2018-12-07 DP AMENDMENT REVISIONS

The following is a summary of design revisions since the last DP Submission dated July 25, 2018.

IVY ON THE PARK

DP AMENDMENT SUBMISSION

FLOOR PLAN - TOWER -
LEVEL ROOF

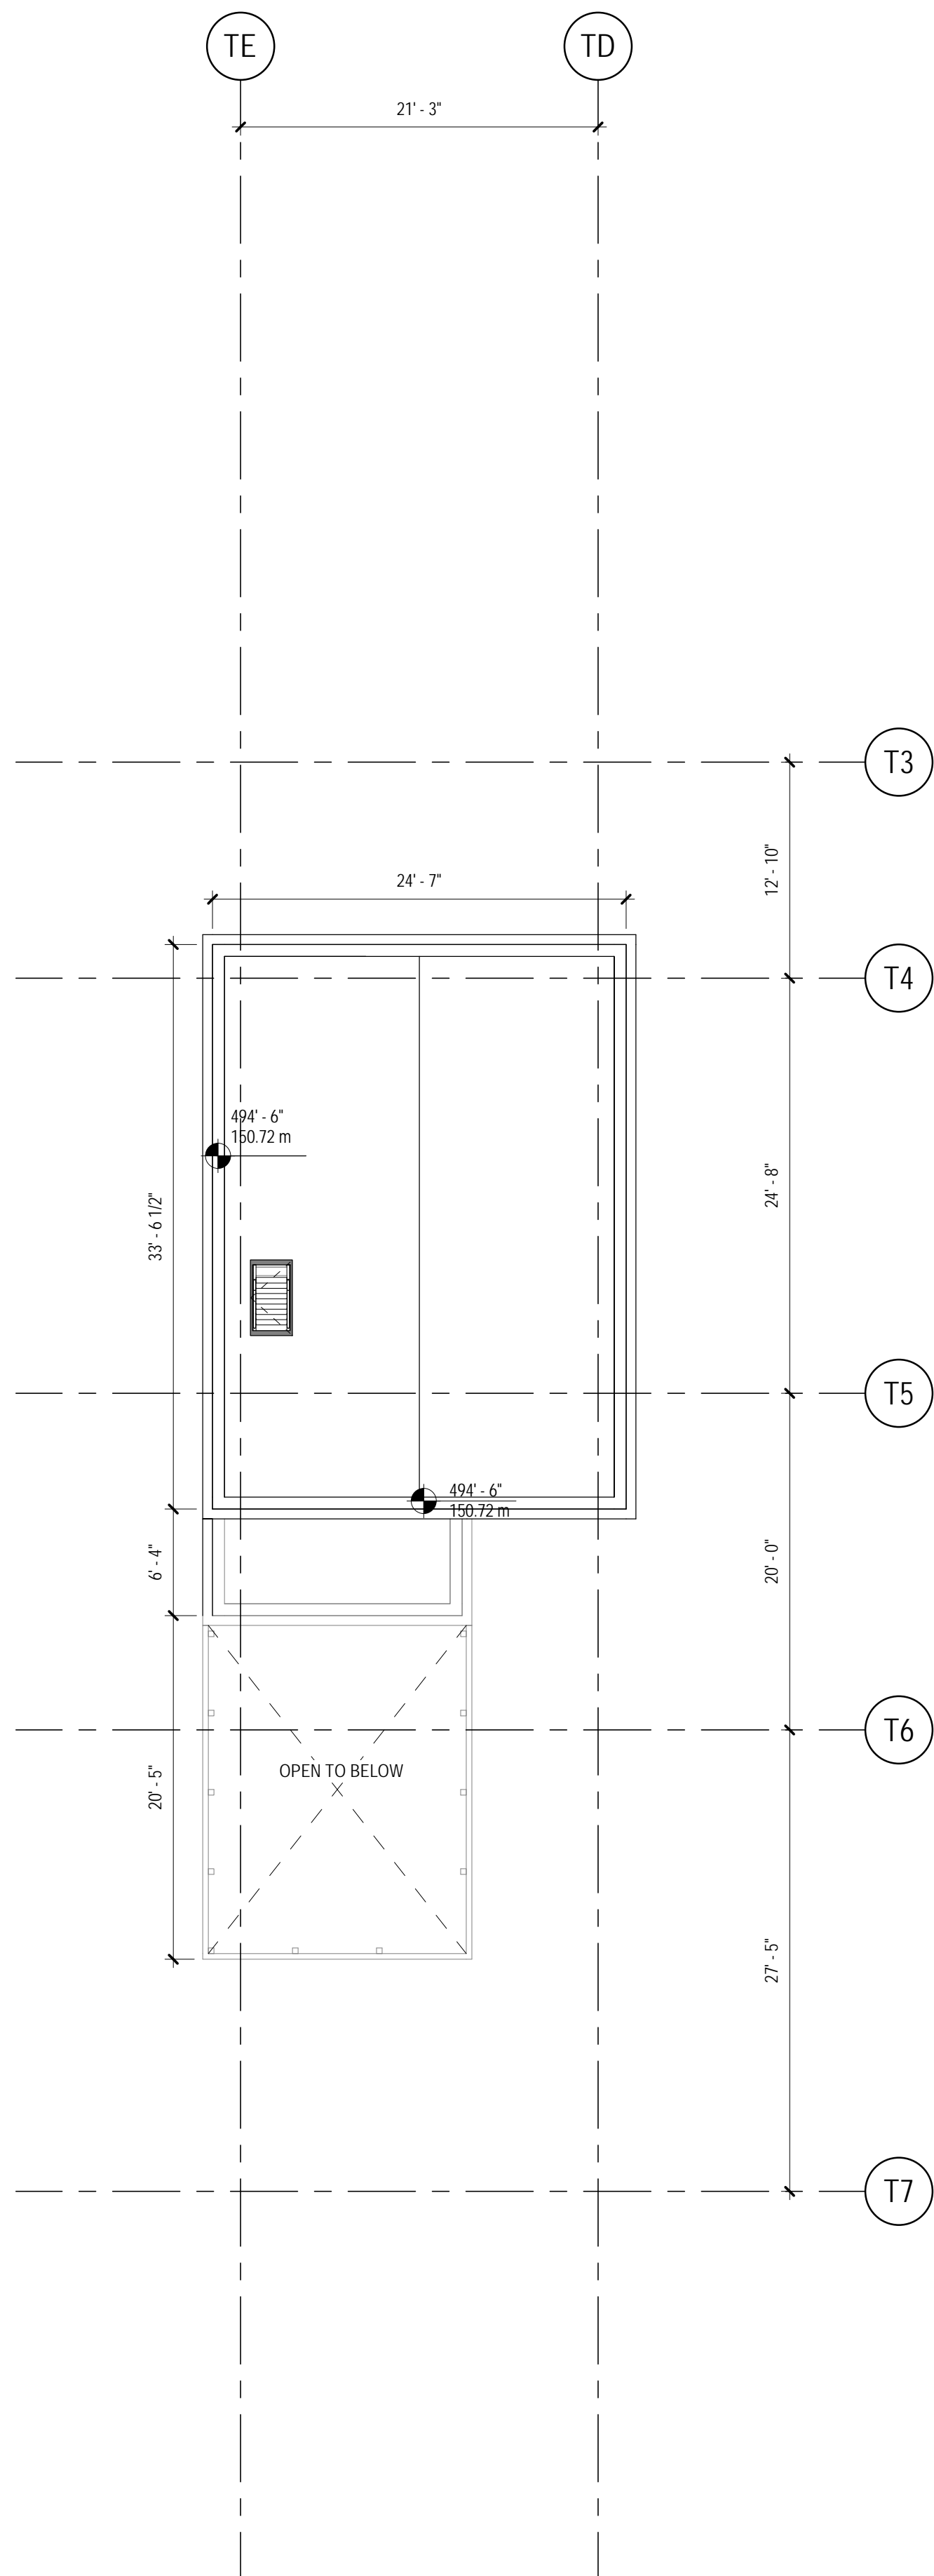
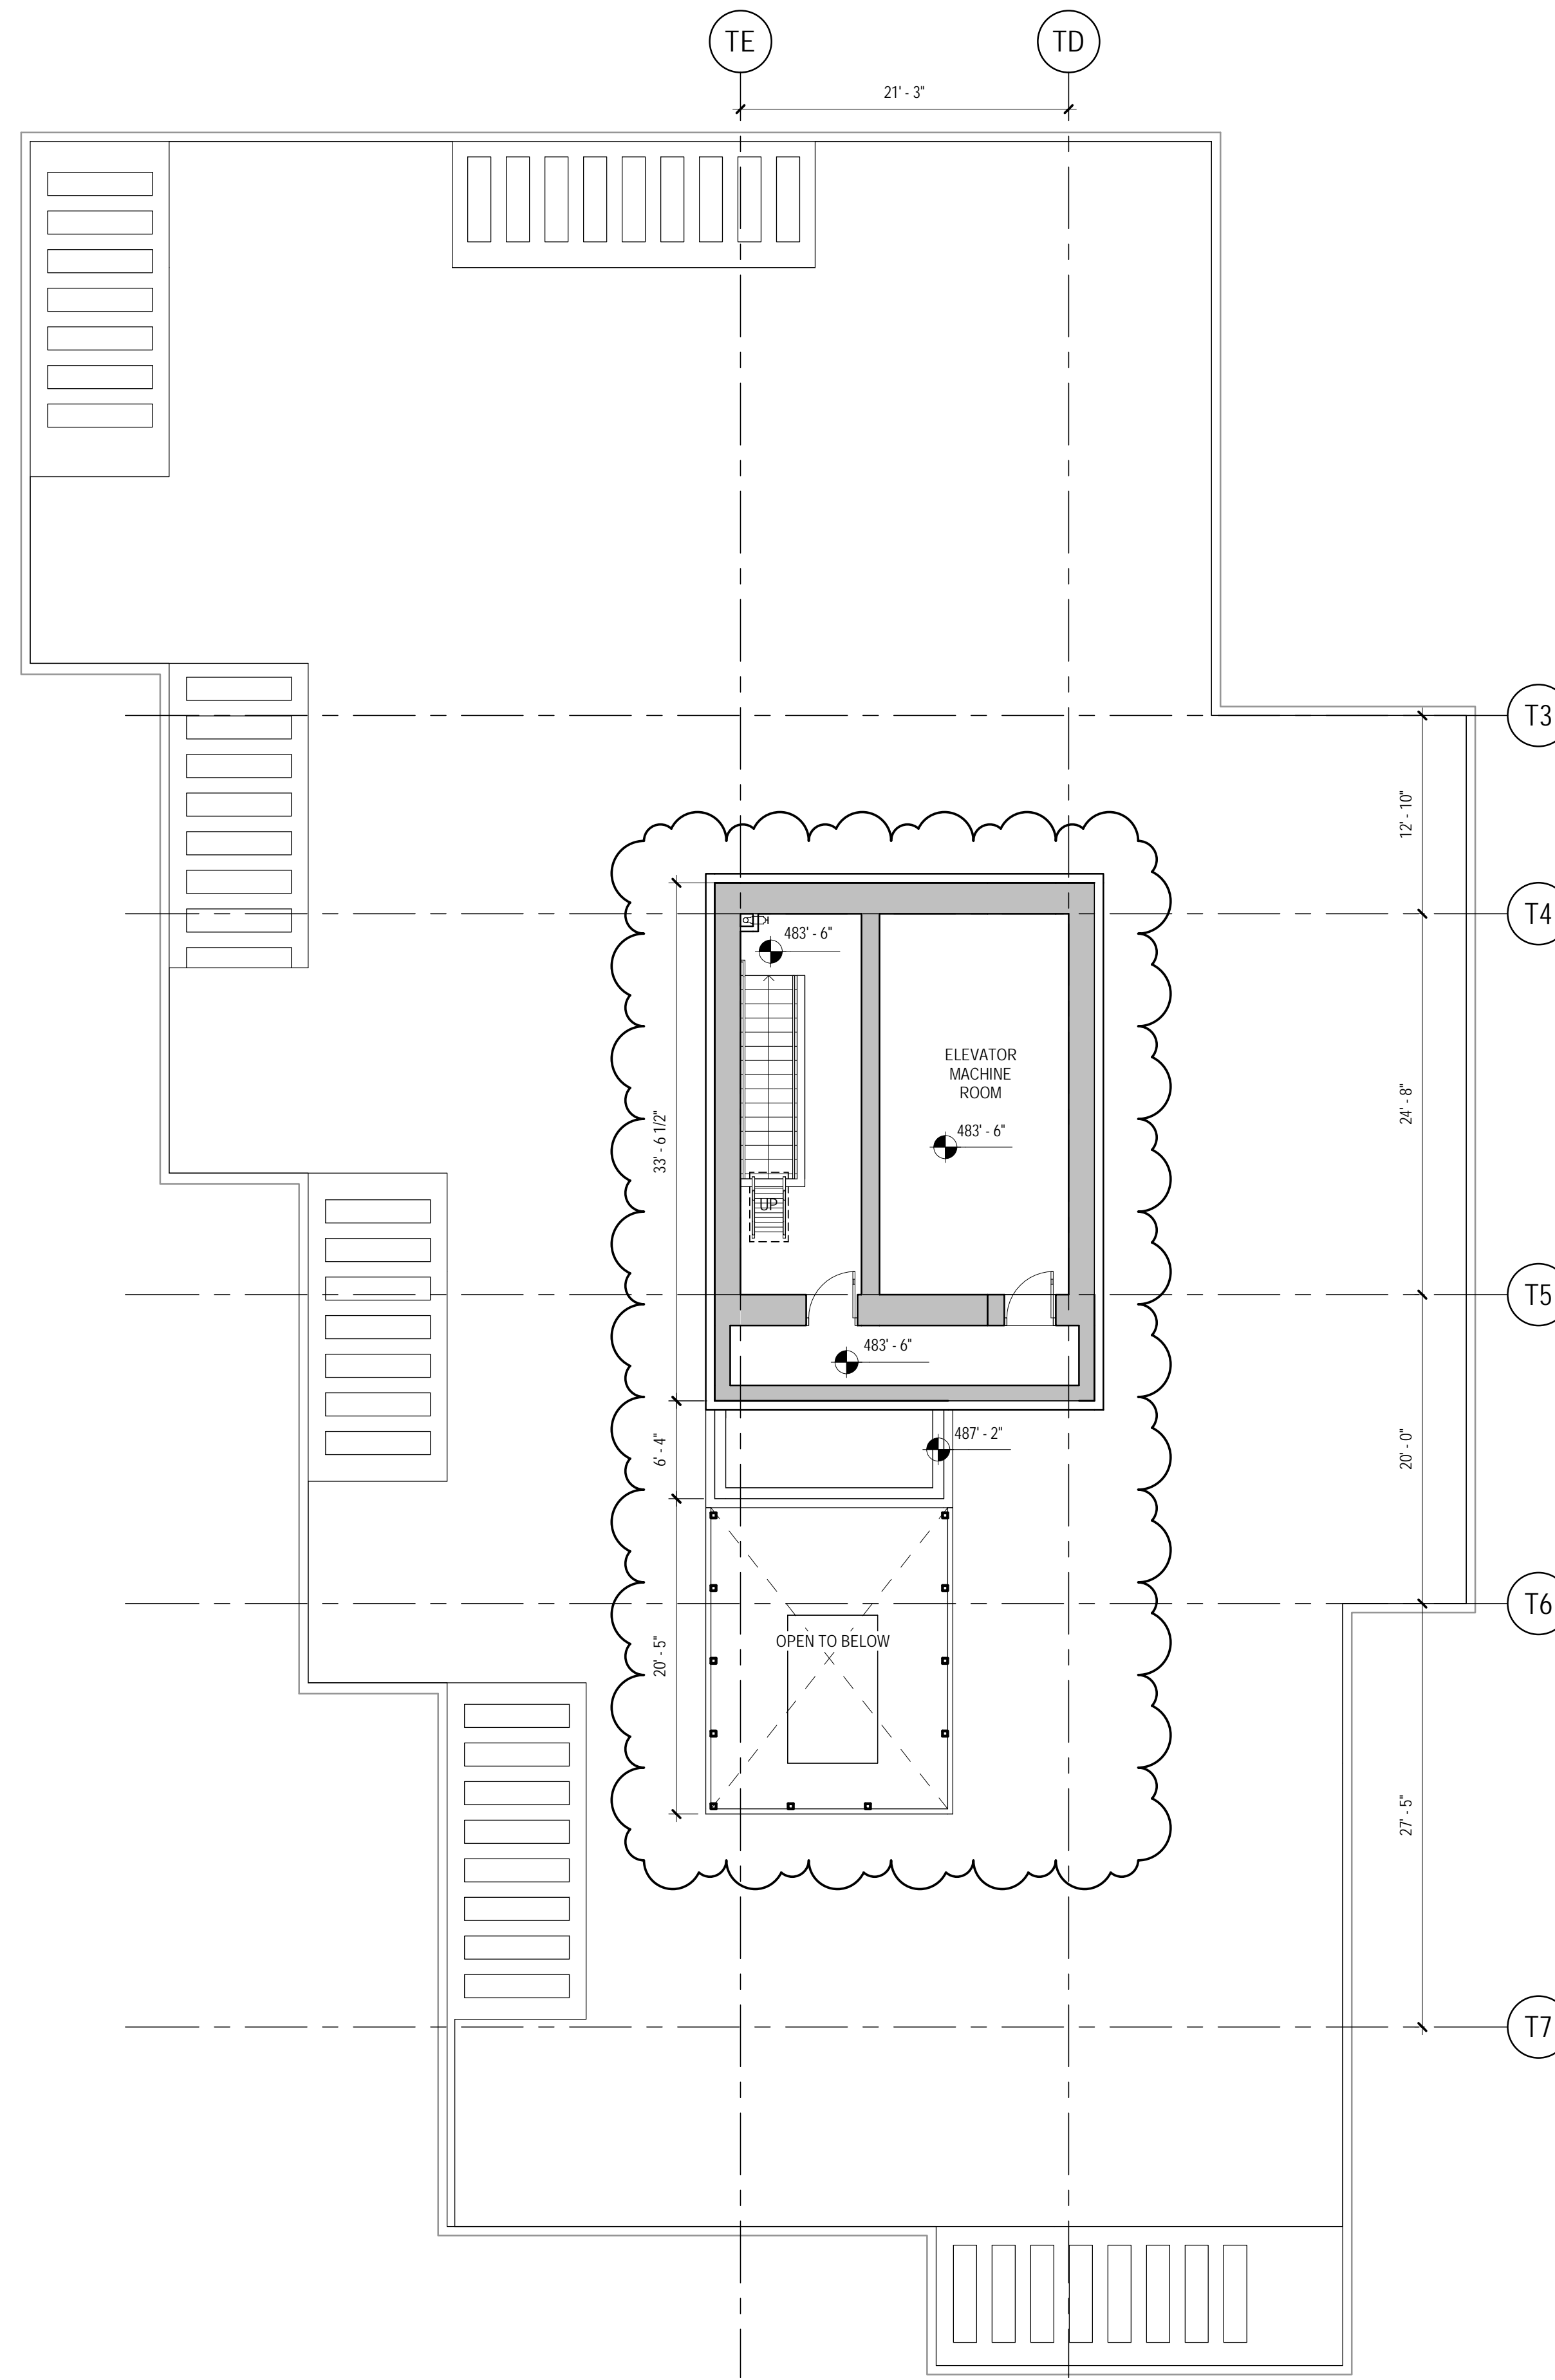
- Tower Level 22 – Additional fancoil units added to Suite 2203 and 2204.
- Roof – Corrugated metal cladding around building elements on roof.
- Steps added to provide roof access. Doors to roof revised.

NORTH ELEVATION

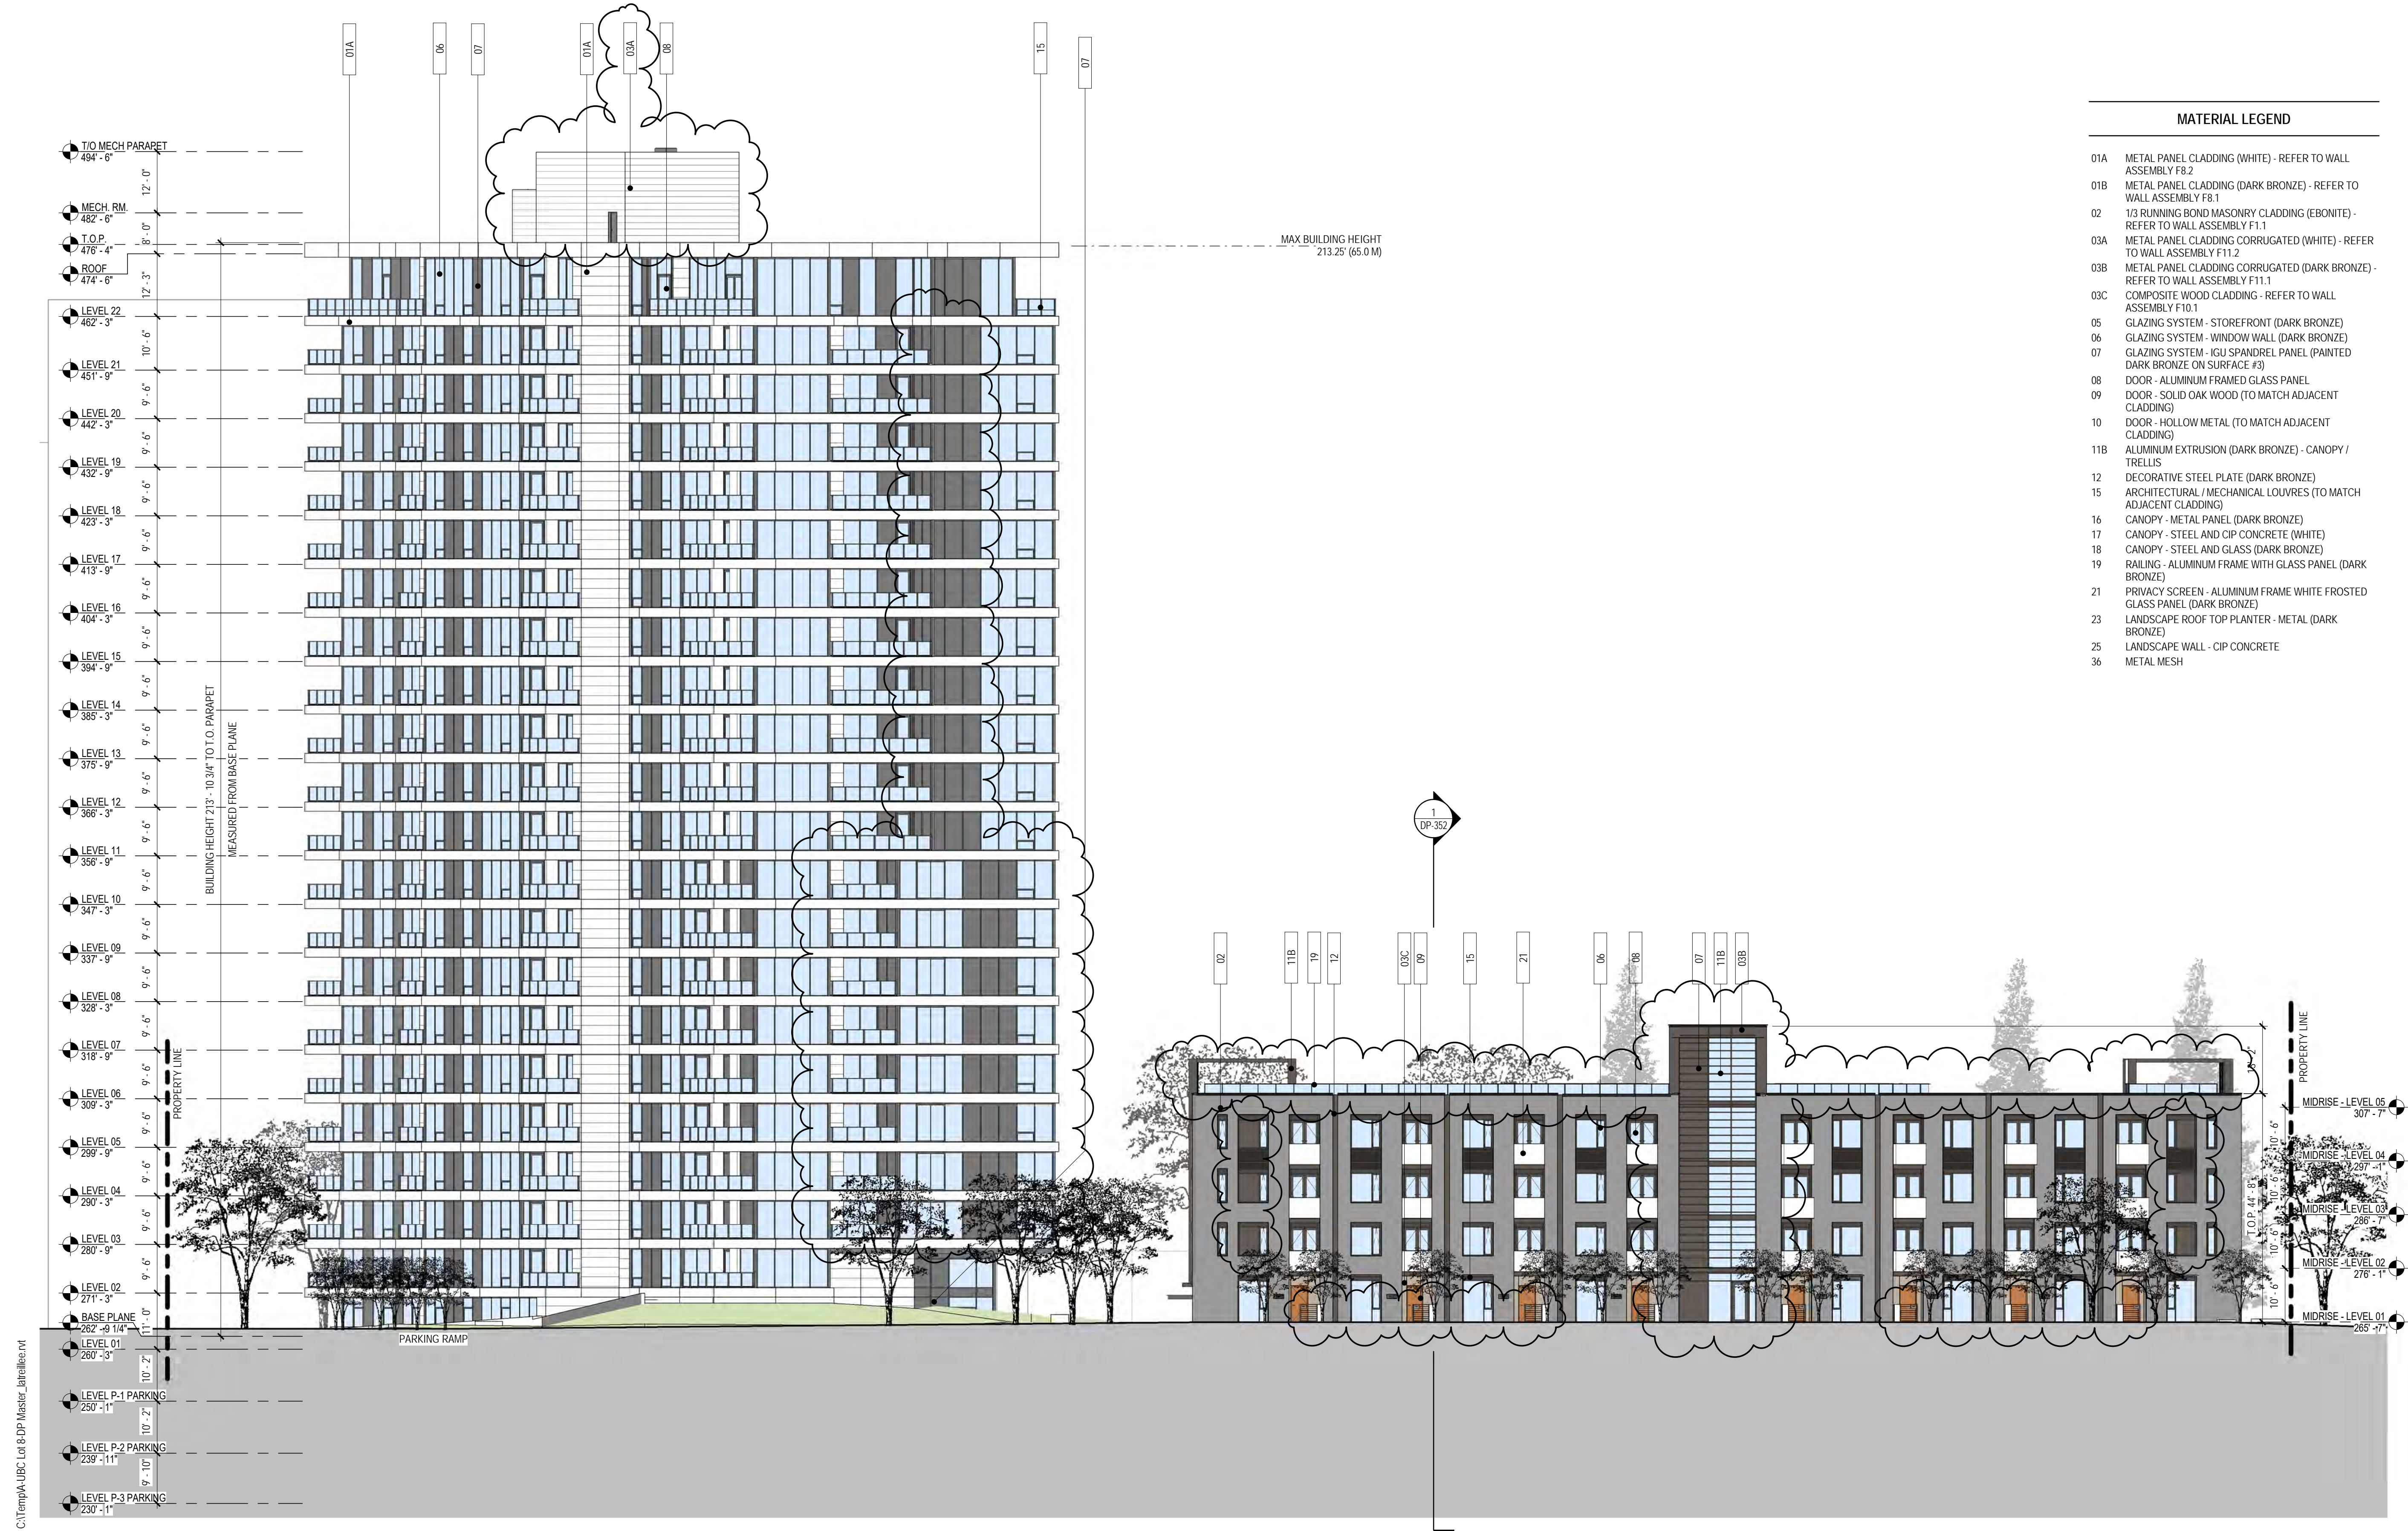
- Column arrangement in the North-West area revised.
- North elevation revised due to suite changes.
- Tower Level 1 – Mail room expanded to accommodate additional suites.
